SCS-VR™ Virtual Receiver Software

FEATURE UPDATE | APRIL 2020

Version 1.4.6 Update

Figure 1: CID String Example

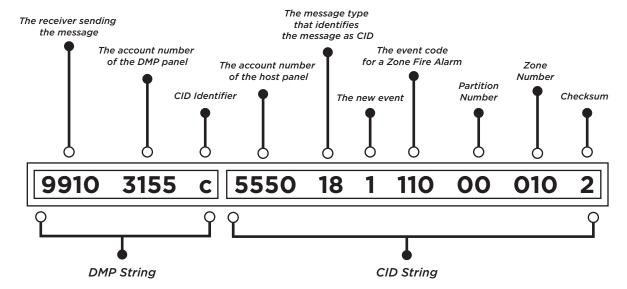
Output Raw CID (ContactID) String

This feature has been added to support the upcoming version 202 firmware of DMP Universal Communicators. This will allow the receiver to process Serial 3 messages received that contain CID (ContactID) event codes within the message. Upon receipt of those messages, it will process only the CID portion of the message out to the Central Station Automation.
